Staff Report

To: Salt Lake City Planning Commission
From: Doug Dansie, Senior Planner, 801 535-6182
Date: July 8, 2015
Re: PLNSUB2015-00075 and 00418 Alpenridge townhomes

Planned Development, Minor Subdivision

PROPERTY ADDRESS: Approximately 620 East 1700 South

**SITE DEMOLITION PLAN
 ARCHITECTURAL SITE PLAN**

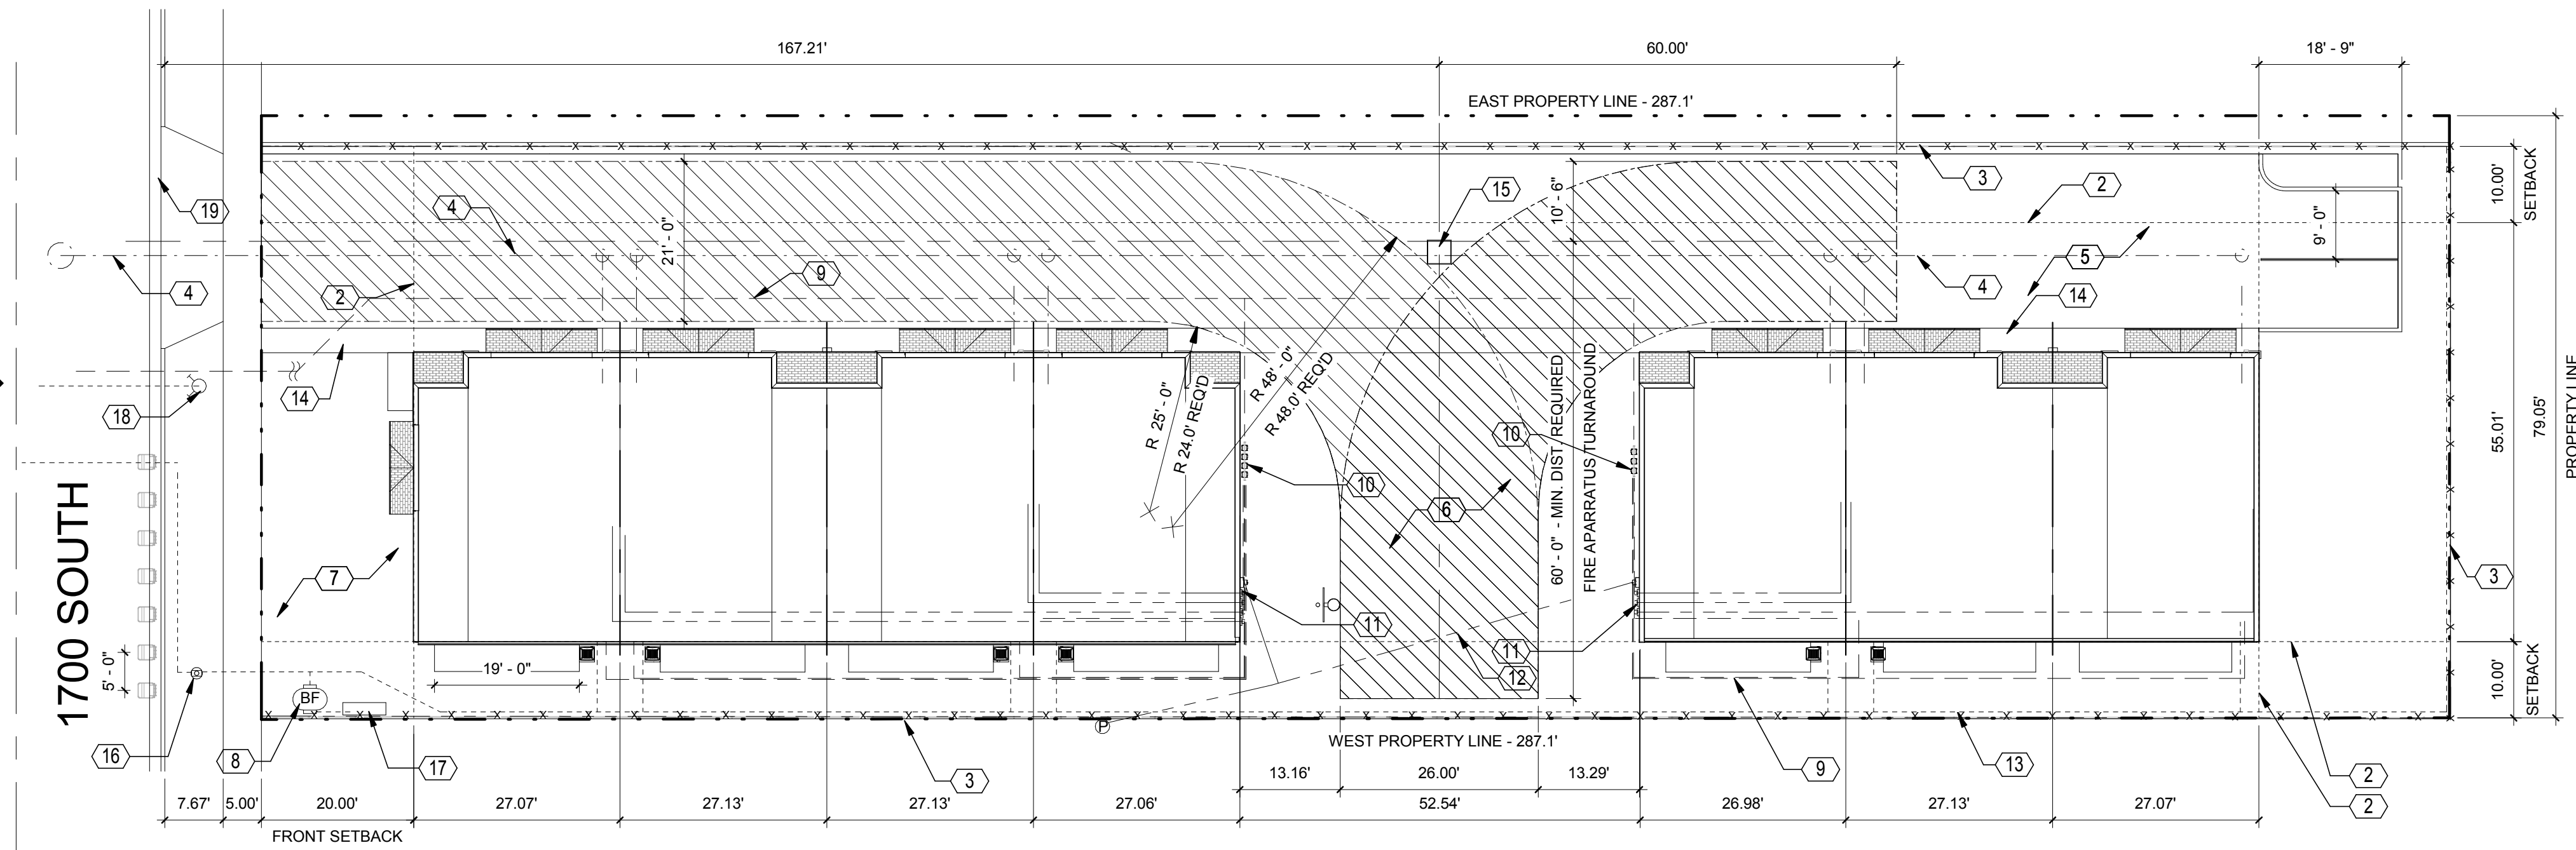
Alpenridge's property is on the right and Mr. Brunatti's property is on the left. As set forth in the plans submitted by Alpenridge, specifically Drawing No. AS101, it appears that Alpenridge indicates that it owns the boundary fence and approximately 4 feet east of the fence, which is actually land owned by Mr. Brunatti. Drawing No. AS101 further indicates that Alpenridge intends to remove the existing boundary fence. The Proposed Development improperly utilizes Mr. Brunatti's property without his permission. For this reason alone, the development should be rejected.

The boundary between Mr. Brunatti's property and Alpenridge's property is delineated by a fence that has been in place since Mr. Brunatti's parents purchased the property in 1947. A picture of the fence between the two properties was included with our first letter to the Salt Lake City Planning Division and Mr. Dansie dated May 14, 2015. In the photograph, Alpenridge's property is on the right and Mr. Brunatti's property is on the left. As set forth in the plans submitted by Alpenridge, specifically Drawing No. AS101, it appears that Alpenridge indicates

that it owns the boundary fence and approximately 4 feet east of the fence, which is actually land owned by Mr. Brunatti. Drawing No. AS101 further indicates that Alpenridge intends to remove the existing boundary fence. The Proposed Development improperly utilizes Mr. Brunatti's property without his permission. For this reason alone, the development should be rejected.

- c) A minimum lot width of eighty feet (80') unless modified by the PLNSUB2015-00075 Planned Development.
 - d) Relocation of the proposed fencing to the east property line to make it clear that the required interior side yard landscaping is to be installed and maintained by the owners of this property.

- j) Correction of Keyed Notes #8 to indicate where the fencing detail can be found (fencing forward of the front façade is limited to four feet (4') in height).

LANDSCAPE PLAN

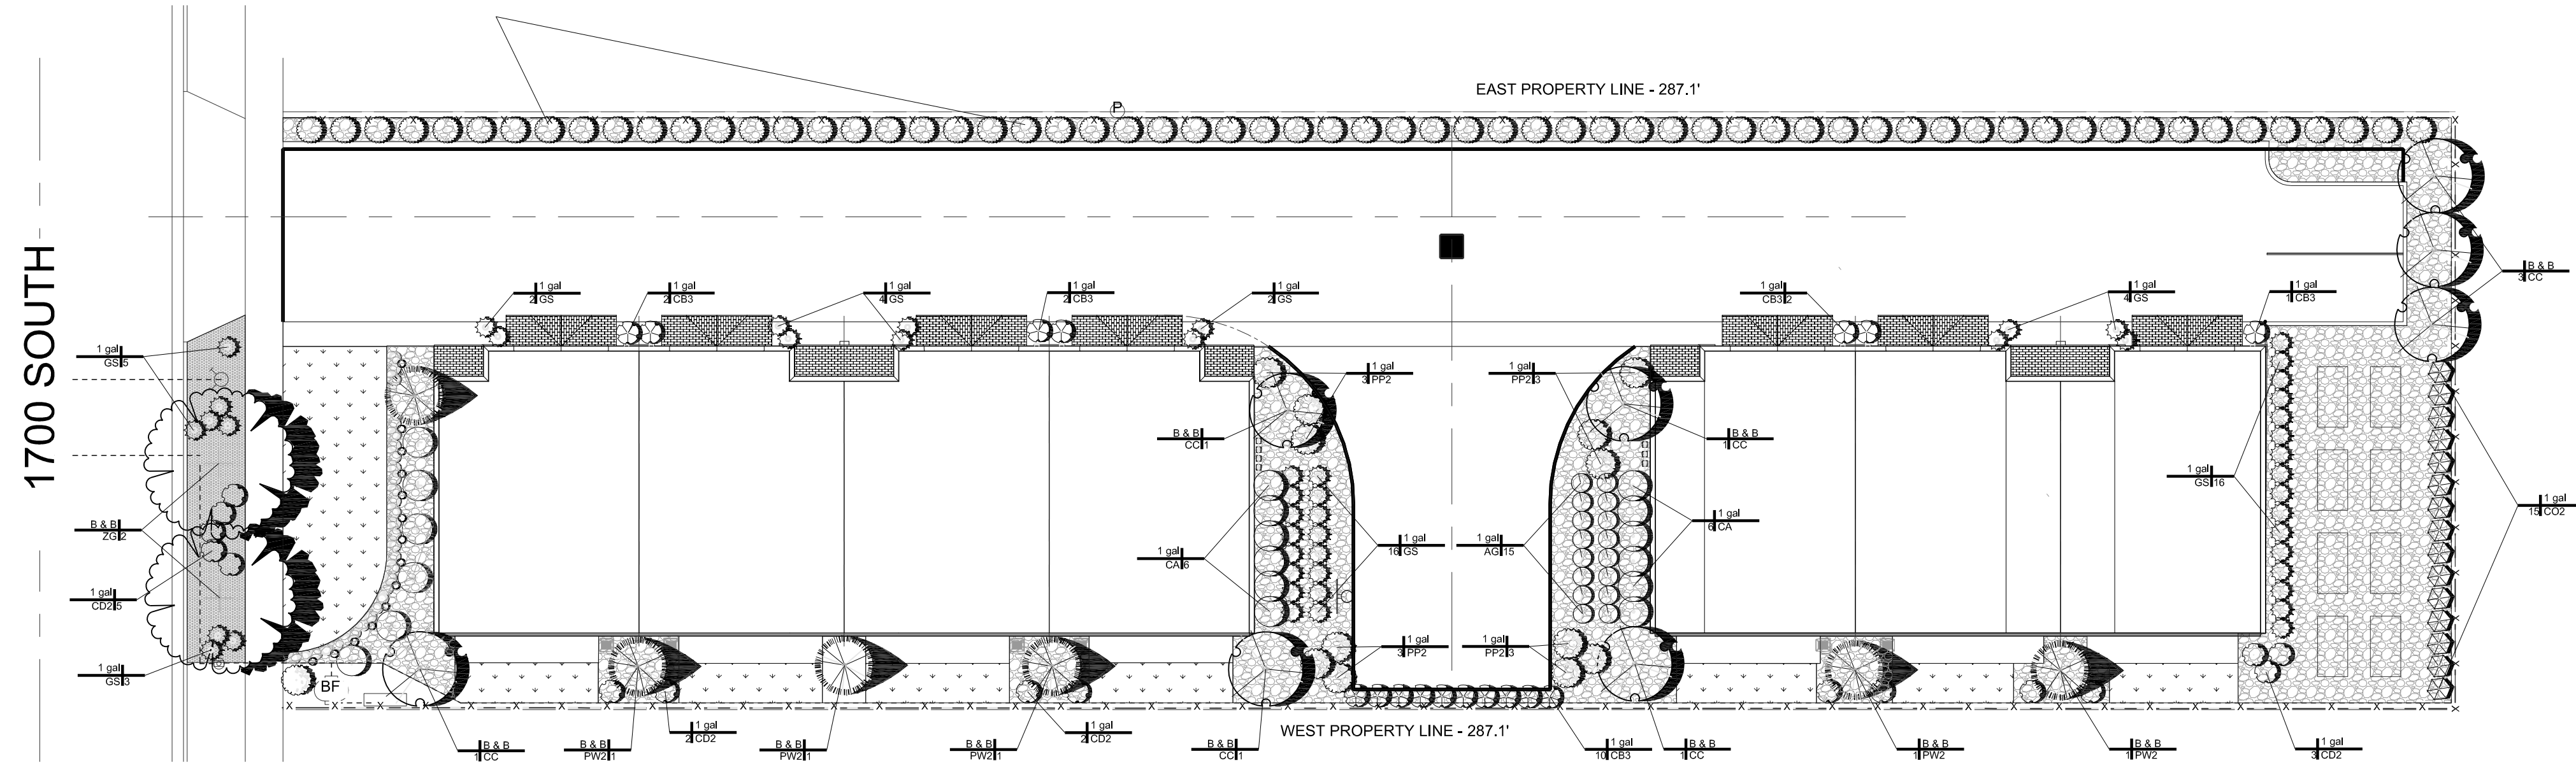
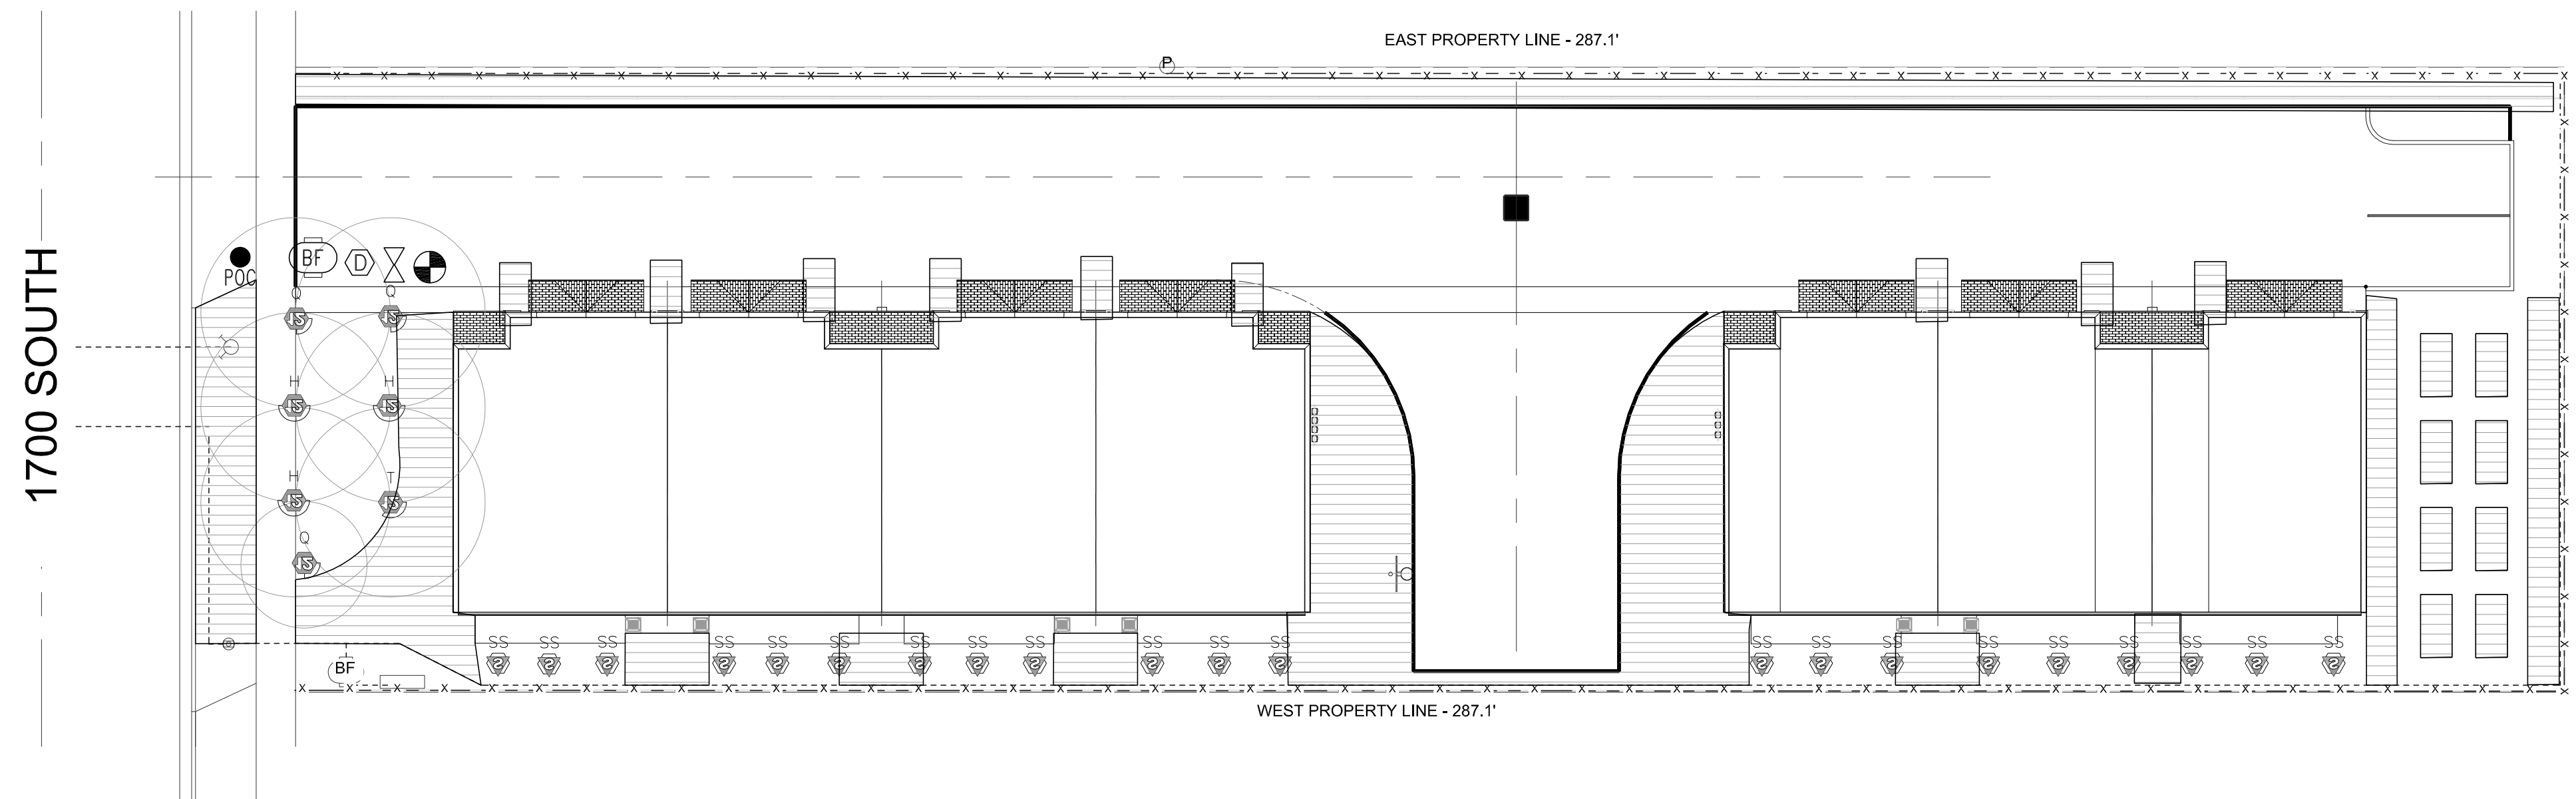
We have reviewed Alpenridge’s most recent plans submitted to the Planning Division approximately two weeks ago. We note that although Alpenridge has turned the buildings 180 degrees from their original position, the plans continue to represent that Alpenridge owns the approximately four feet of Mr. Brunatti’s property. And while the proposed fence appears to be in the same location of the currently existing fence, the Landscape Plan indicates that Alpenridge will plant and maintain a row of pine trees on Mr. Brunatti’s side of the boundary, where his mature trees and landscaping currently exist.

We believe an appropriate solution to help comply with Salt Lake City Ordinance 21A.55.050(E) and resolve the parties’ dispute over the property would be to amend the Landscape Plan to indicate that the land will be kept in its current historical condition, with the trees, shrubs, and other landscaping remaining the same. Mr. Brunatti will continue to maintain

We would like to ensure that there is adequate privacy between our property and the new townhomes. From what I can see on the current landscape design, there are mugo pines along the fence line (the western boundary for townhomes)- it seems these would provide minimal, if any, privacy. If we are interpreting the below code correctly, it looks like there should be shade trees incorporated in a minimum of 4' for the height of the evergreen hedge. It also looks like the buffer does not provide the full 10' required.
